**GARNET ENERGY CENTER
ARTICLE 10 EXHIBIT 24**

OUTREACH CORRESPONDENCE

Subject: Visual Impact Survey Request – Garnet Energy Center

MAP 3

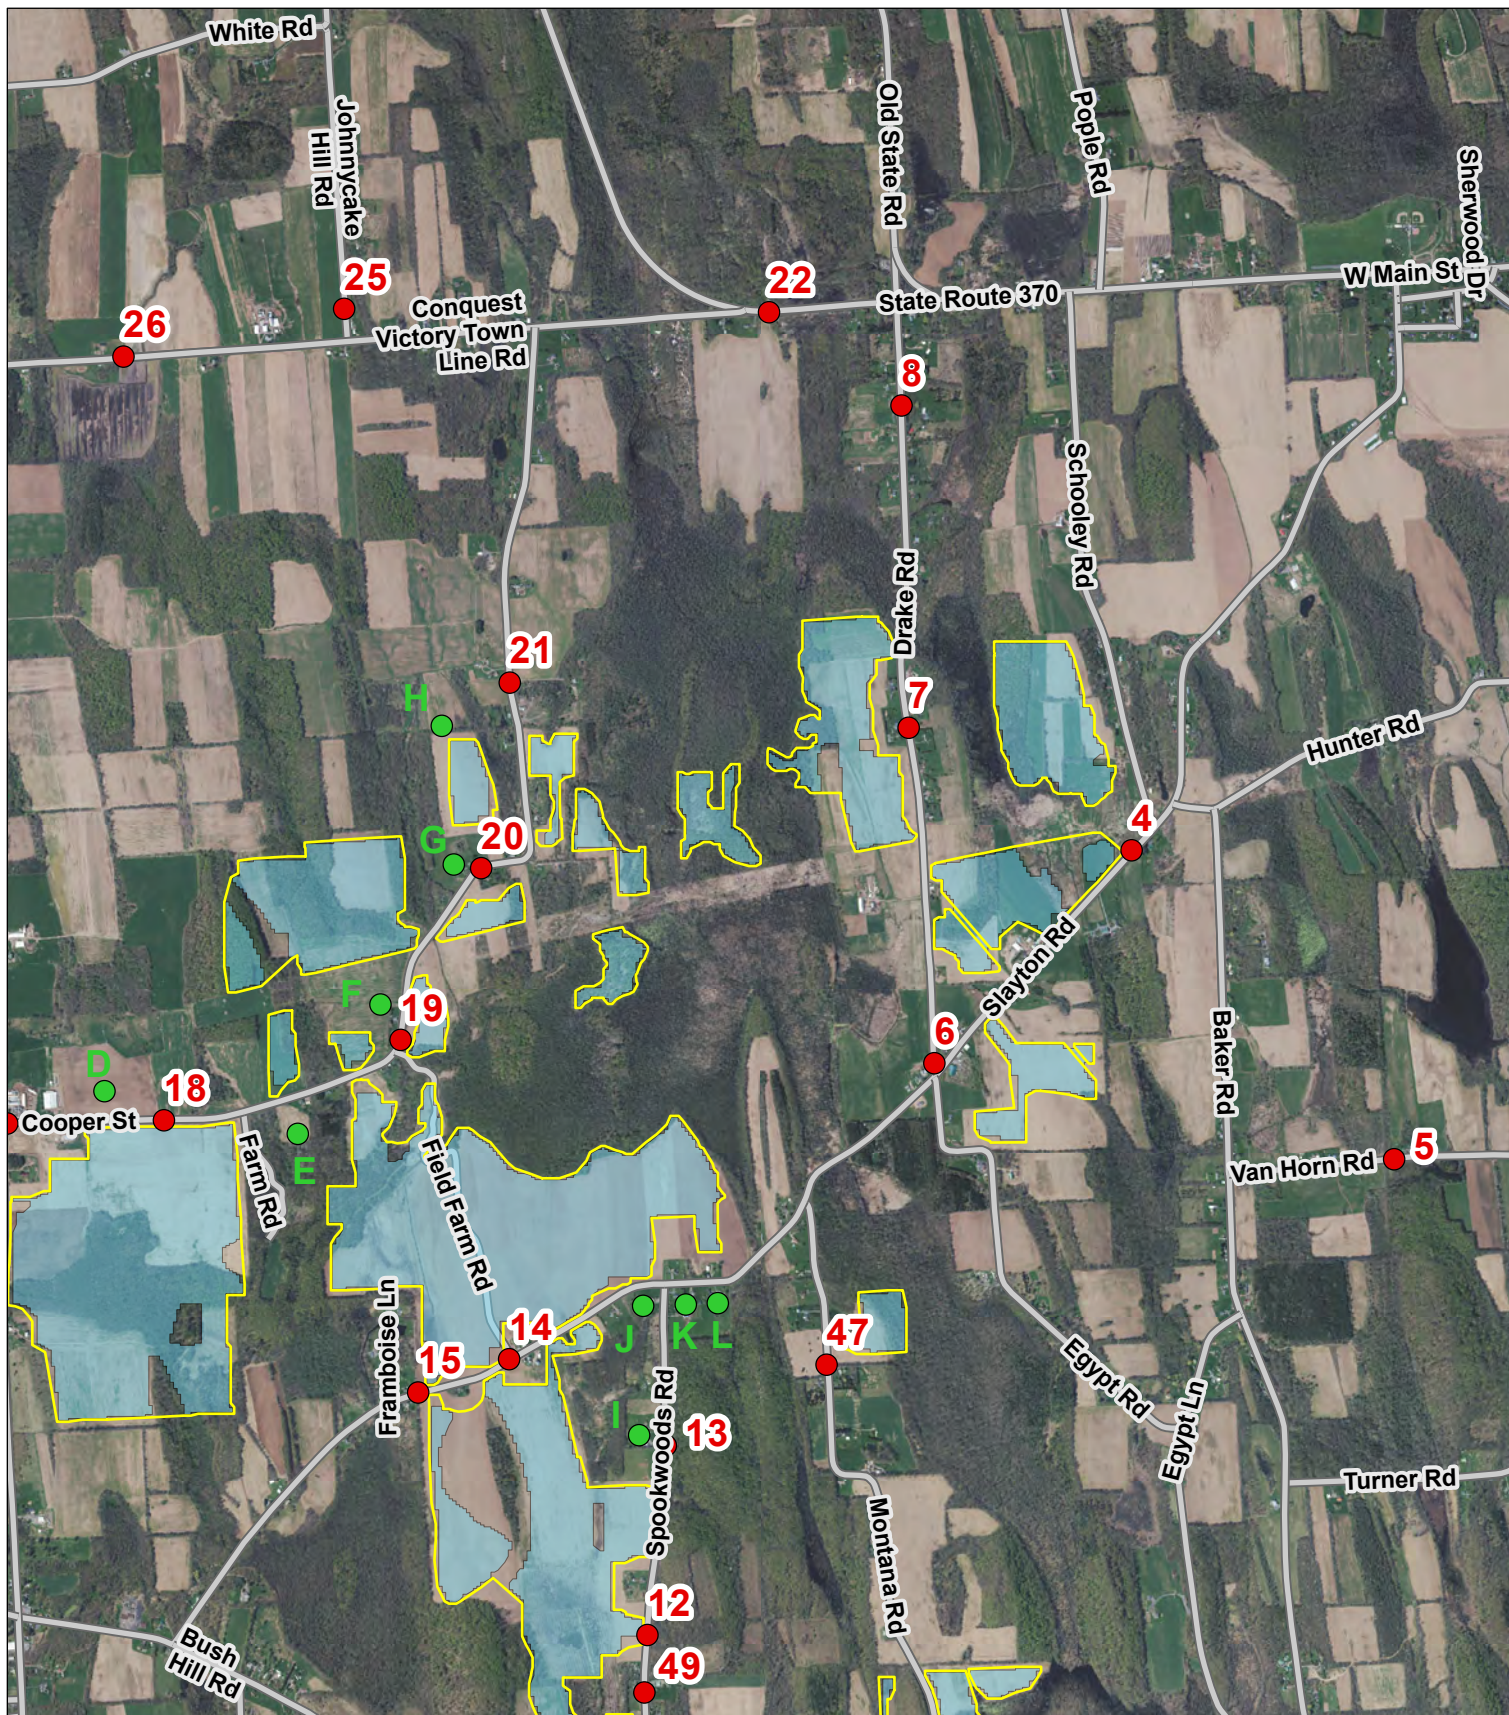
On behalf of the Town of Conquest, please refer to the two attached figures which identify 12 additional viewpoint locations (labeled as A through L on the attached figures). This information is being provided in response to your Visual Impact Survey Request that was emailed to the Town on January 27, 2021. Upon your review of the attached, please feel free to contact me if you have any questions or would like to discuss.

- PHOTO VIEWPOINT
- ADDITIONAL PHOTO VIEWPOINT REQUESTED BY THE TOWN
- PROPOSED ARRAY LOCATIONS
